Date: September 06, 2005
 To: T10 Committee (SCSI)
 From: George Penokie (IBM/Tivoli)
 Subject: SAM-4: Converting to UML part 1

1 SAM-4 changes

Figure 4 — Logical unit class diagram

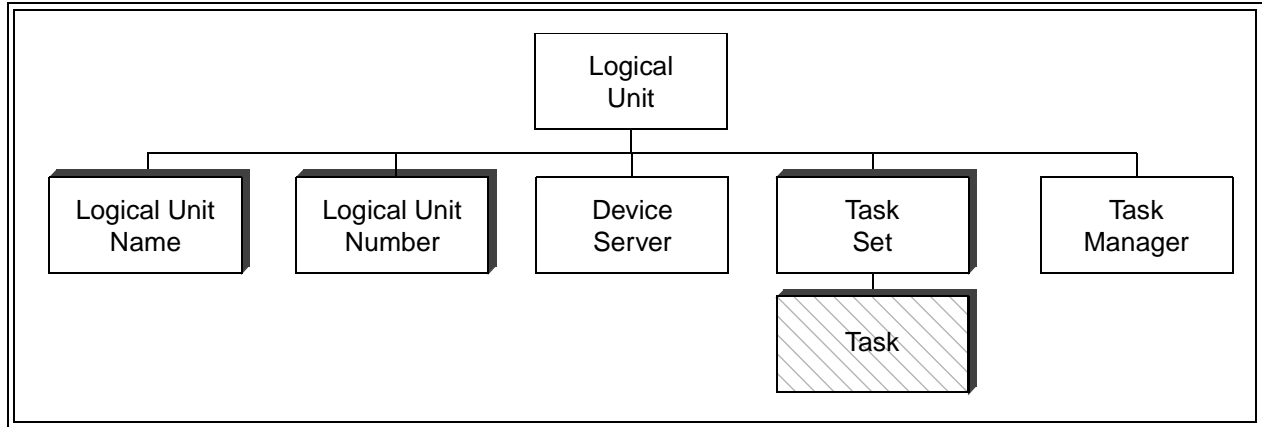
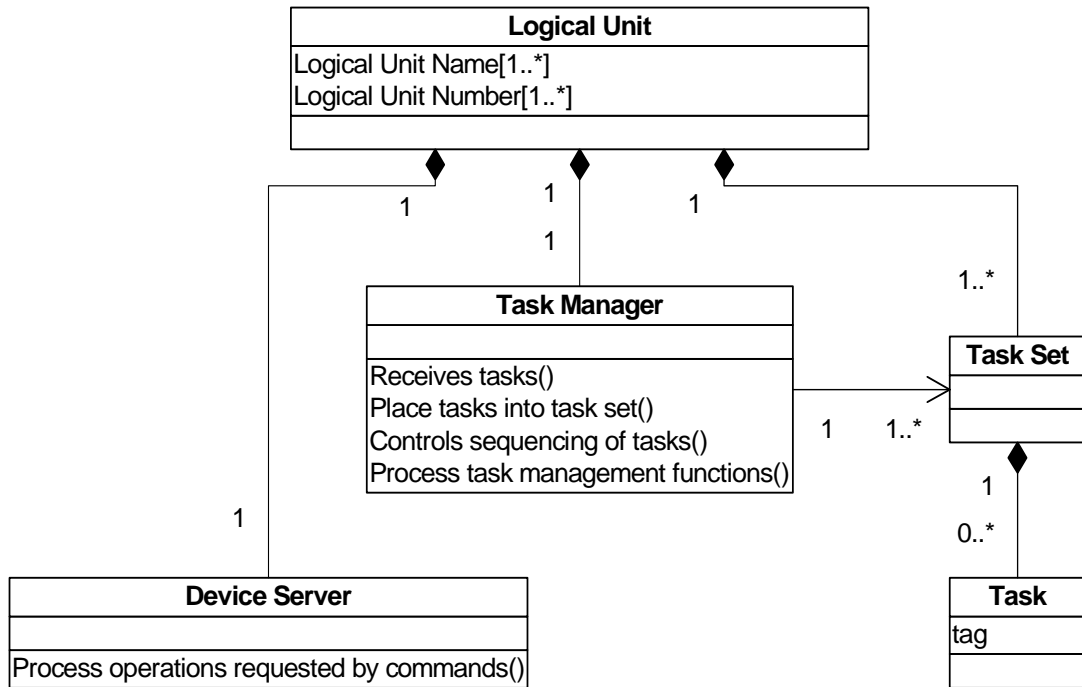
For an example of what figures in SAM-4 would look like a converted logical unit model (see figure 3) as currently shown in SAM-4 would look like what is shown in figure 4.
